# Rework Procedure for P3 (29-42 MHz 110 Watt)

## Low Band Orion Radio

Revision PA4: March 29, 1999

This manual provides instructions for upgrading an Orion Low Band Radio (High Split, High Power), Ericsson part number 344A4576P3, from revision "D" to revision "E".

FIG.1

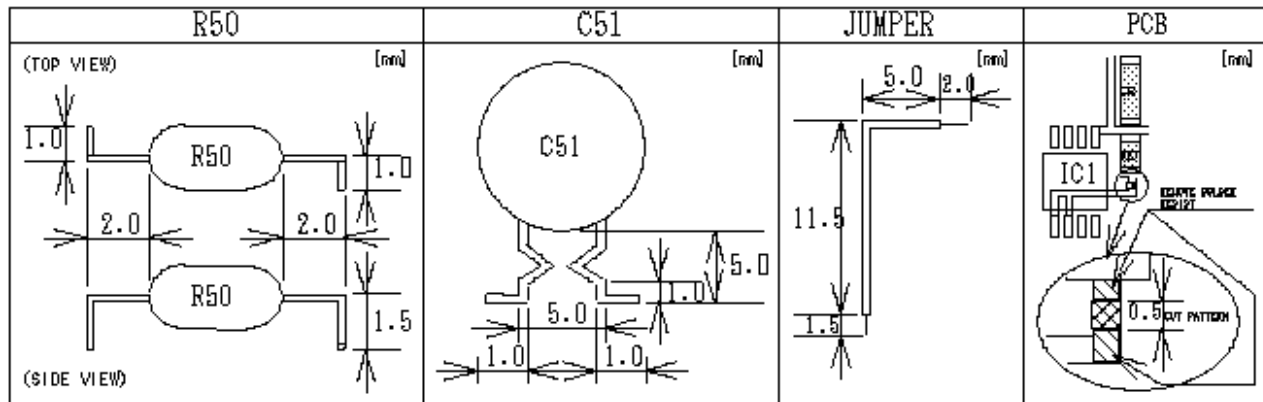
1. Remove and discard IC-2 (comparator)
2. Remove and discard C82
3. Remove and discard R21
4. Remove and discard R22
5. Remove and discard R23
6. Remove and discard R28
7. Cut trace on PWB near IC1 and R27 (in the exact location as shown in Figure 1)
8. Add R49 (560 ohms) between pin 1 and 2 of IC1, and R27 (as shown in Figure 2)
9. Form the leads of R50 (as shown in Figure 1), then add R50 (1K ohm) between R27 and the ground at C52 (as shown in Figure 2)
10. Install a jumper from the pin 6 pad for IC2, to R25 (as shown in Figure 2)
11. Using the silicone sealant, stake down the jumper wire (as shown in Figure 2)
12. Form the leads of C51 (as shown in Figure 1), then using the silicone sealant for mechanical stability, install one end of C51 (.01uF) to the C55 / IC1 pin 6 junction, and install the other end of C51 to the ground at C56 (as shown in Figure 2).

FIG.1

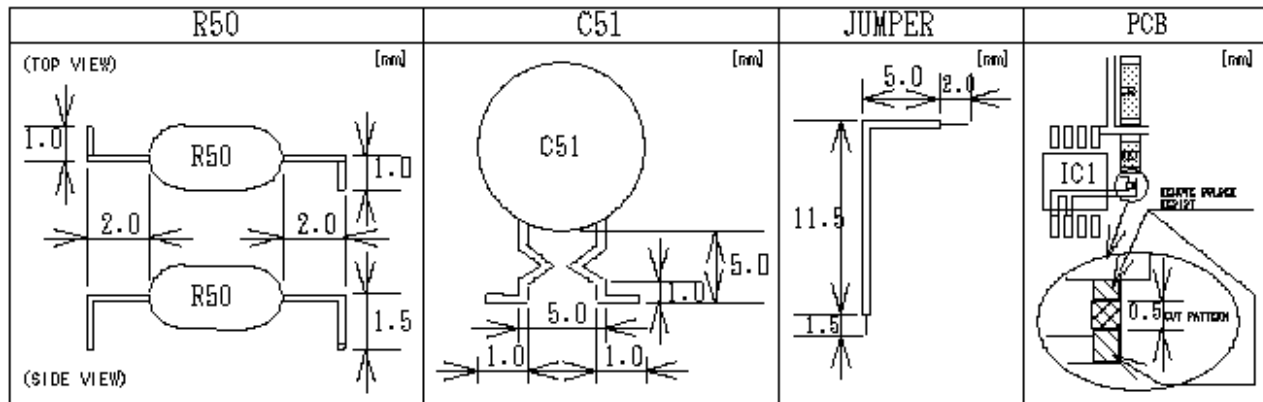
1. Remove and discard IC-2 (comparator)
2. Remove and discard C82
3. Remove and discard R21
4. Remove and discard R22
5. Remove and discard R23
6. Remove and discard R28
7. Cut trace on PWB near IC1 and R27 (in the exact location as shown in Figure 1)
8. Add R49 (560 ohms) between pin 1 and 2 of IC1, and R27 (as shown in Figure 2)
9. Form the leads of R50 (as shown in JRC Figure 1), then add R50 (1K ohm) between R27 and the ground at C52 (as shown in Figure 2)
10. Install a jumper from the pin 6 pad for IC2, to R25 (as shown in Figure 2)
11. Using the silicone sealant, stake down the jumper wire (as shown in Figure 2)
12. Form the leads of C51 (as shown in Figure 1), then using the silicone sealant for mechanical stability, install one end of C51 (.01uF) to the C55 / IC1 pin 6 junction, and install the other end of C51 to the ground at C56 (as shown in JRC Figure 2).
